From: James Cox
Sent: 27 November 2018 16:39
To: Rob Smith
Cc: 'Robert Staniland'
Subject: Woodsmith Mine - Phase 6a (NYM/2018/0663/CVC) [NLP-DMS.FID262297]

Please find attached the following updated plans which reflect the proposed amendments to the LNG facility (see application ref. NYM/2018/0662/NM):

The attached plans supersede those that were submitted on 5th October 2018. In summary, the proposed amends reflect the following amendments to the LNG facility:

Woodsmith Mine
Construction Phase 6a
LNG / Generator Plant
Sections

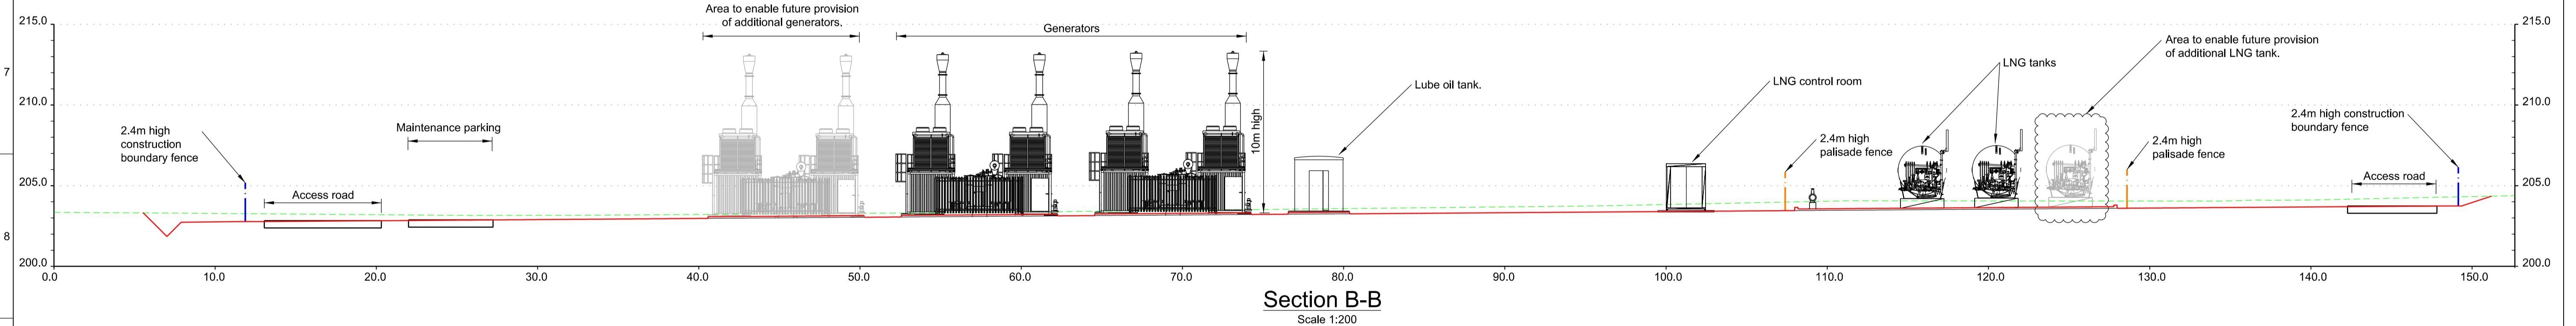
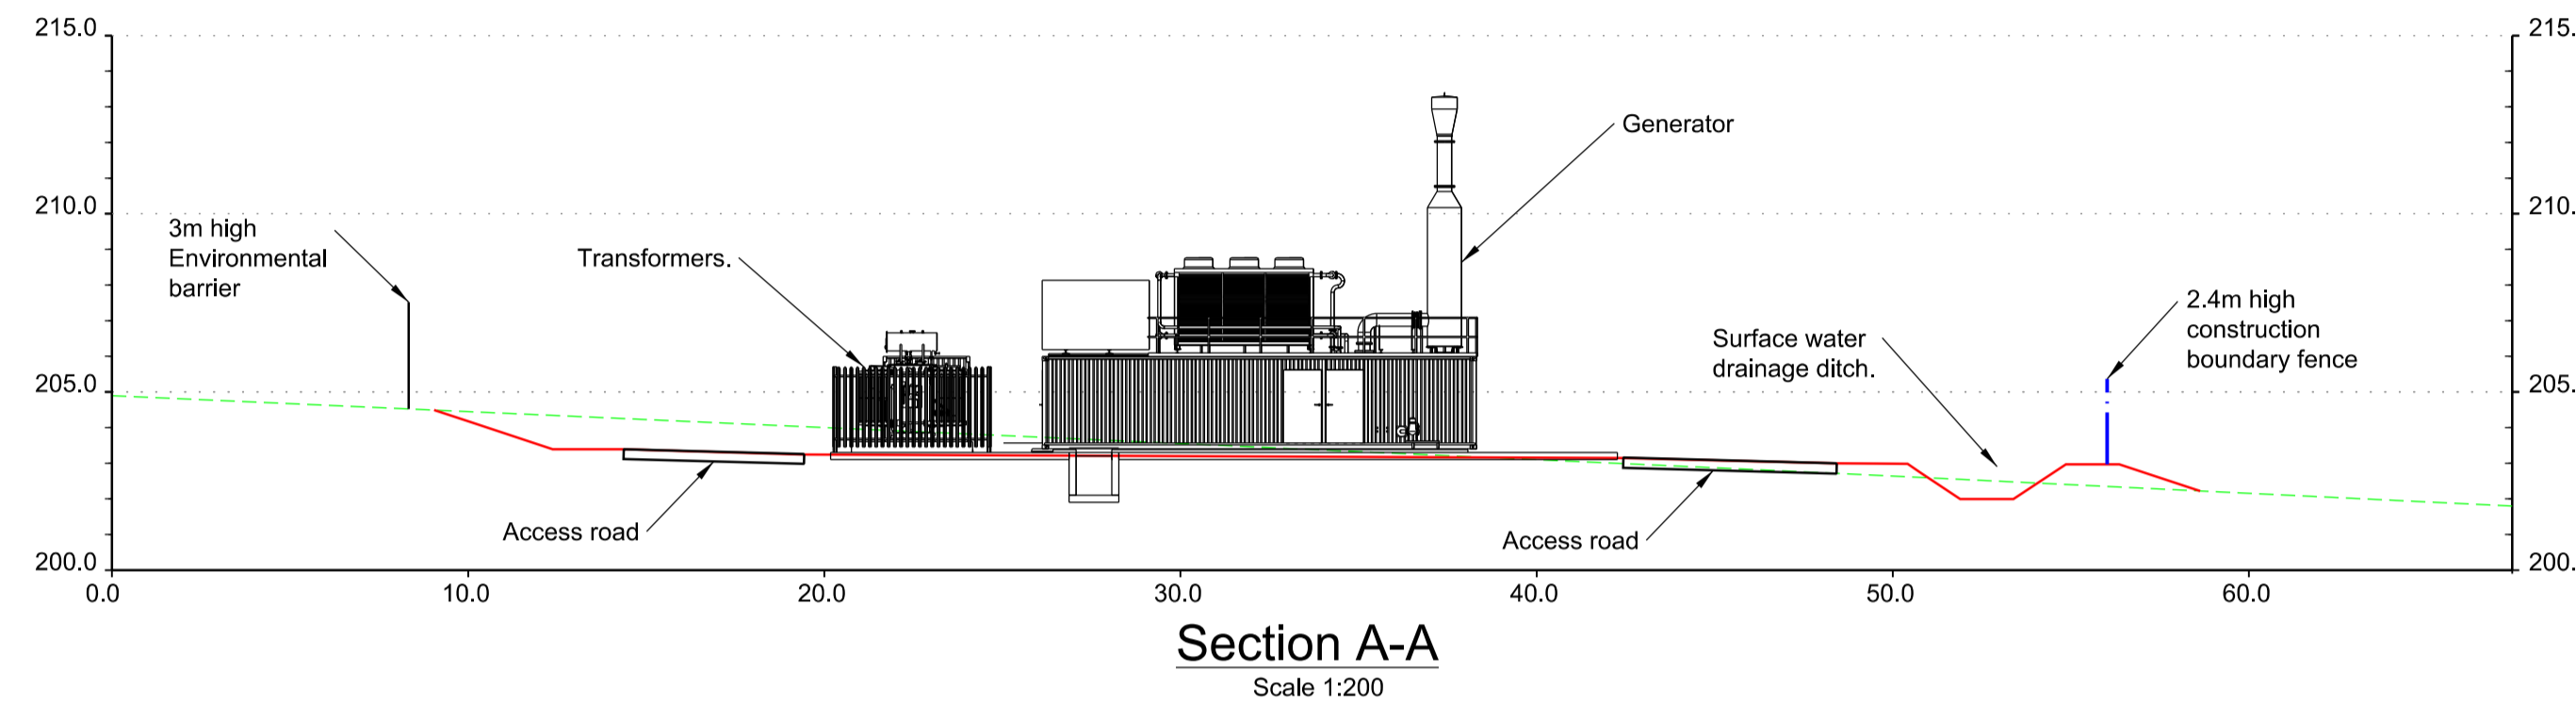
- i. A revised lighting scheme;
- ii. The removal of fire water and foam storage tanks; and
- iii. The introduction of a 3m timber screening fence at the south-western boundary of the site.
